## AMENDMENTS TO THE DRAWINGS

## REMARKS

FIG. 6a

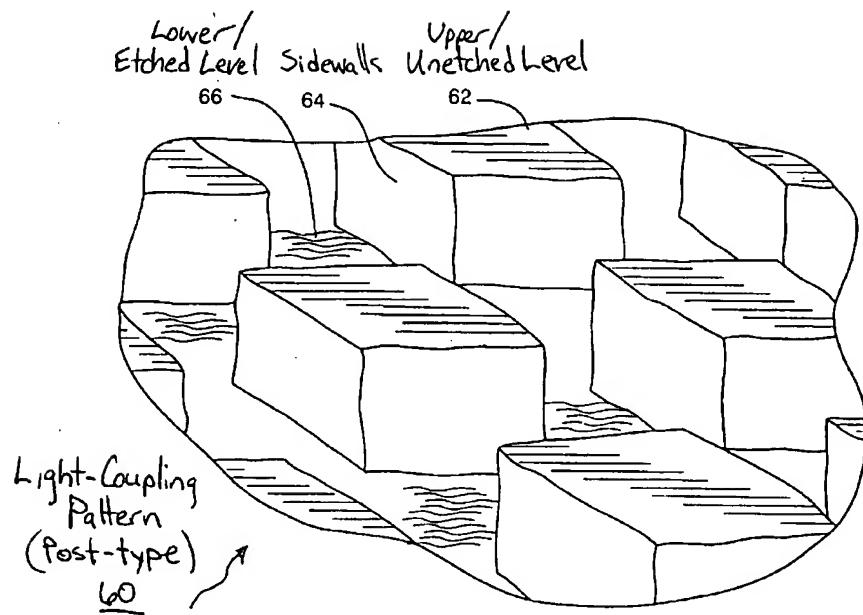
FIG. 6a – handwritten text replaced with typed text ; label “Light-Coupling Pattern (Post-type) 60” has been amended to “Light-Coupling Pattern (Post-type) 70” to more clearly distinguish the post type grating from the waffle type grating.

In more particular detail, Applicant has amended Figure 6a to denote the post-type grating as element 70 and the waffle-type grating of Figure 6b is denoted as element 80. Figure 7a has been amended to include a reference label for "Pixel 90" to note that the structure is a pixel. This aids in understanding the orientation of the grating 60 on the pixel 90, wherein the grating is oriented to the edges of the pixel 90. Reference number "60", "62", "66" has been added to more clearly identify the "Light-Coupling Grating Pattern 60" and the "Posts 62" and "Wells 66". The term "Holes" has been amended to "Wells" to more clearly identify the well structures. This is for clarification purposes and corresponding changes to the specification are included herein.

Applicant believes that the specification and drawings clearly illustrate a waffle configuration, wherein the structure resembles a waffle having wells instead of posts. For illustrative purposes, Applicant directs the Office to Figures 6a and 6b of the present application which are presented herein. Figure 6a shows a number of posts while Figure 6b shows a waffle configuration with wells etched out, leaving the grid lines in relief to form the sidewalls of the wells and the lower level forming the floor.

In distinction to the post configuration, the electromagnetic waves first encounter the reflector grid (Fig. 6a - lower level) which is closer to the quantum wells than the reflector islands (Fig. 6a – upper level).

FIG. 6b

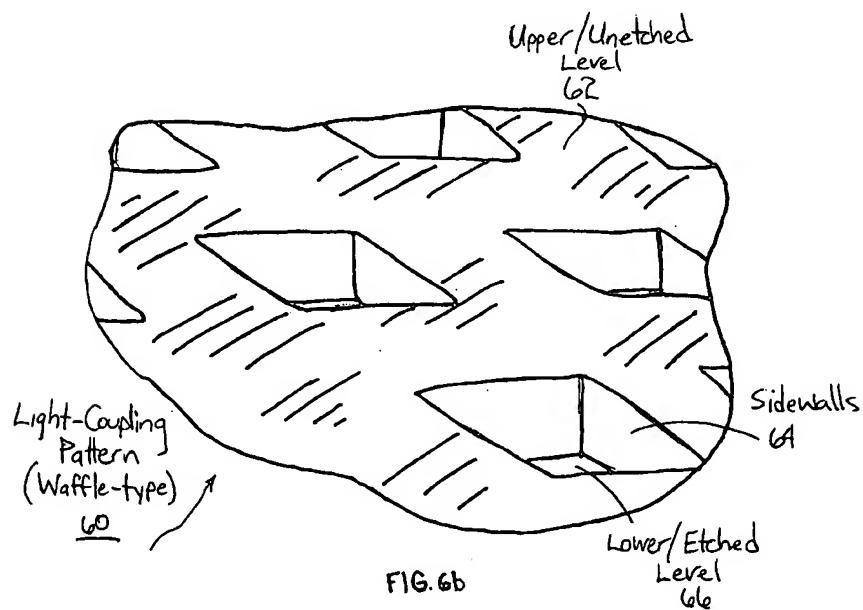
FIG. 6b – handwritten text replaced with typed text; label “Light-Coupling Pattern (Waffle-type) 60” has been amended to “Light-Coupling Pattern (Waffle-type) 80” to more clearly distinguish the post-type grating from the waffle-type grating.

posts to leave the posts. For clarification purposes, the claims have been amended to match the specification description with respect to ‘wells’ in stead of ‘holes’, as the wells of the present invention have sidewalls (Fig. 6b – 64) and a lower level (Fig. 6b - 66)

A pixel is a complicated three dimensional cavity with respect to electromagnetic waves. For example, taking a frame of reference of an electromagnetic wave in the well or cavity of the waffle configuration, the light (electromagnetic waves) enters from the backside as shown in Figure 2. Looking at the waffle grating surface from inside the pixel, the electromagnetic waves ‘see’ a periodic array of reflector islands (Fig. 6b - lower level 66) closer to the quantum wells and the reflector grid (Fig. 6b - upper level 62) further away from the quantum wells.

As shown in the figure of the article, the diffraction grating is either a plurality of hexagonal holes or patches – it is not a waffle structure having the elemental structure shown in Figure 6b of the present application.

FIG. 1

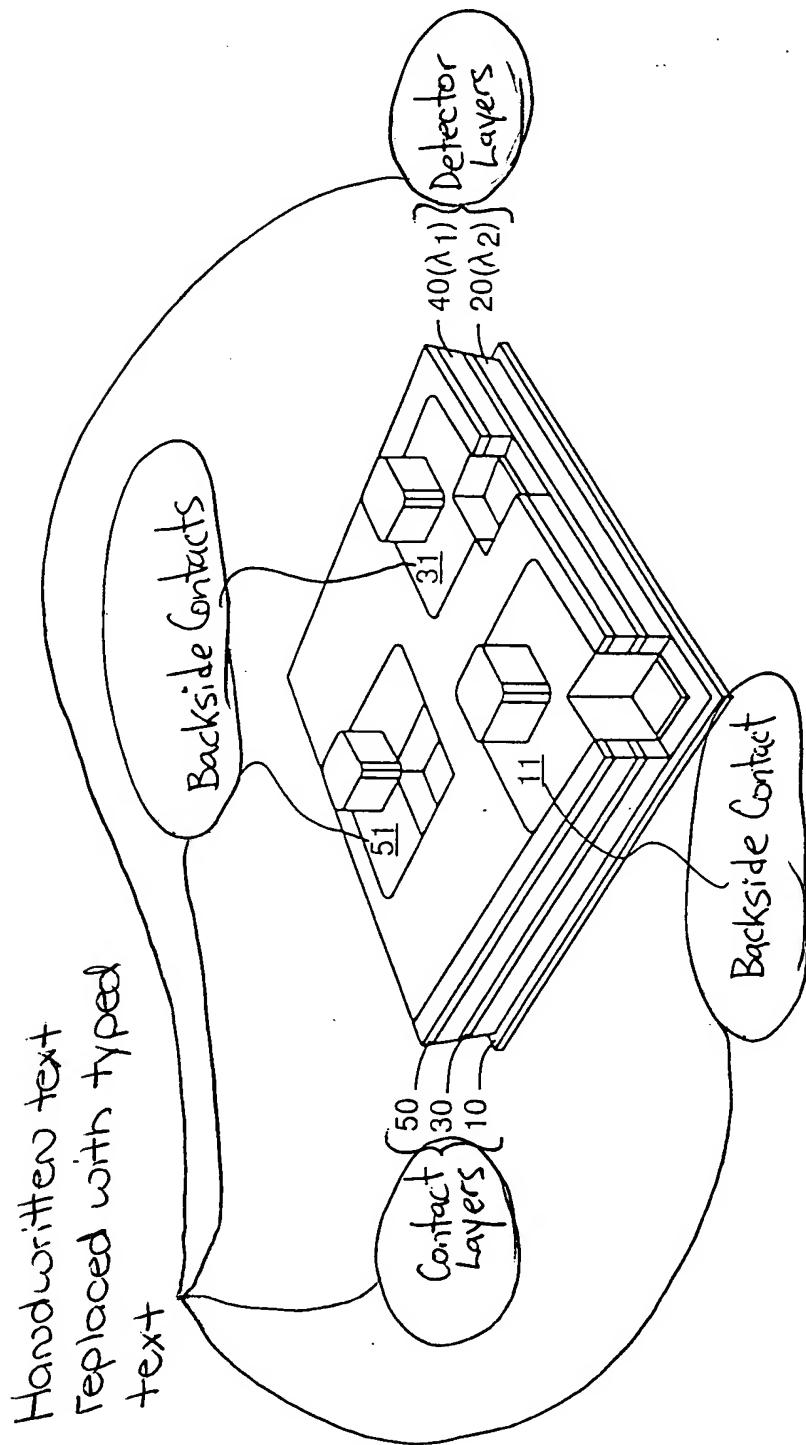
FIG. 1 – handwritten text replaced with typed text

FIG. 2

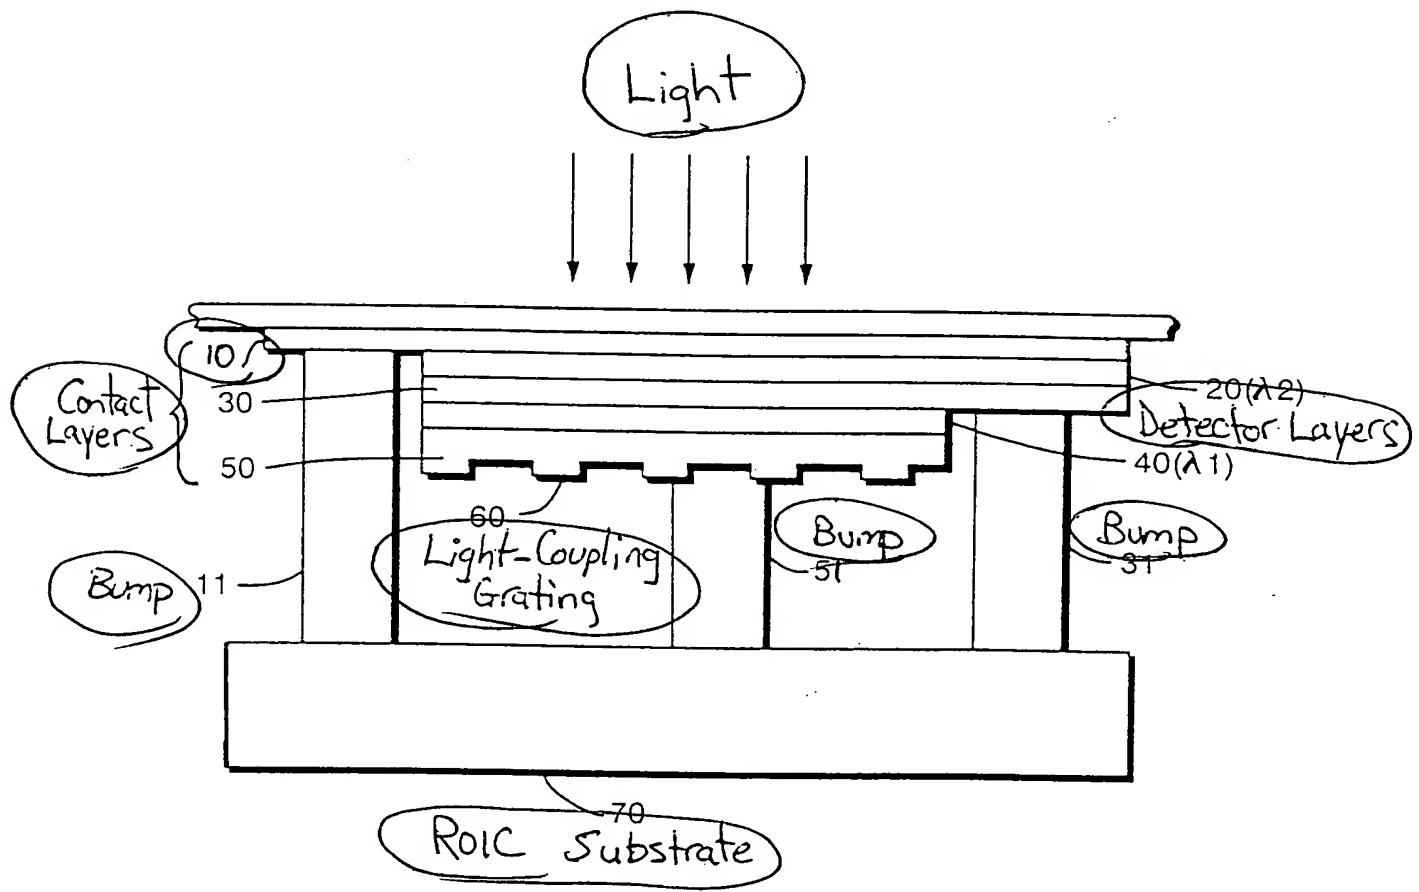
FIG. 2 – handwritten text replaced with typed text

Handwritten text replaced  
with typed text

FIG. 4

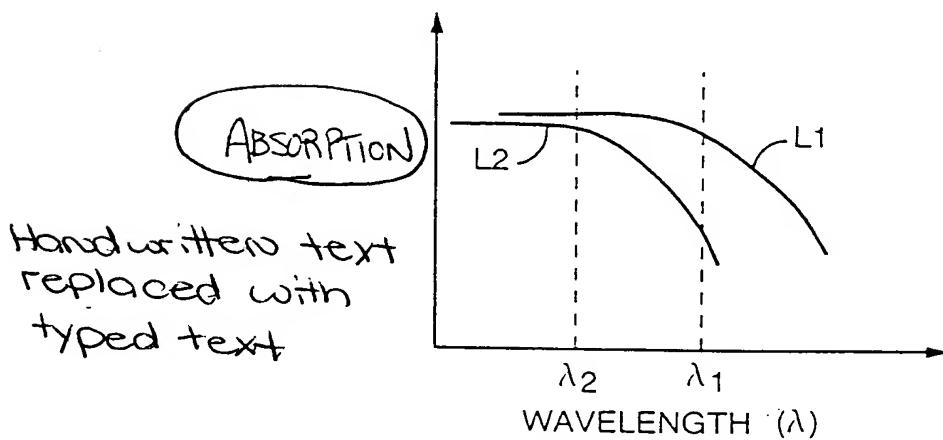
FIG. 4 – handwritten text replaced with typed text

FIG. 7e

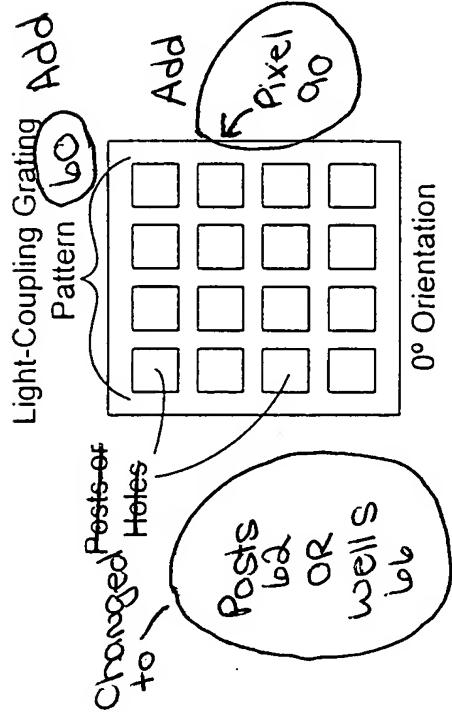
The Office also finds the orientation relationships to lack a point of reference. As explained in the application and illustrated in Figures 7a - 7f, the pattern of the grating 60 is oriented to the “major edges of the pixel.” The pixels of Figure 7a – 7f are shown as being approximately square or rectangular and the various grating patterns for 0 degrees and 45 degrees with respect to the major edges of the pixel for different arrays are depicted. As known in the art, the orientation is with respect to the edges of the pixel, for example the edges establishing 90 degree x and y axes. The claims have been amended to clarify this aspect.

A further rejection is based on the orientation aspects of the claims wherein the grating can be oriented with respect to the pixel as shown in Figures 7a – 7f. For example, a square pixel having 30 micron sides can have a waffle-type grating on the top layer with the grating shifted in relation to the sides of the pixel. The array of wells of the waffle-type grating can be shifted with respect to the sides of the pixel. The claims have been amended to indicate that the orientation is with respect to the major sides of the pixel.
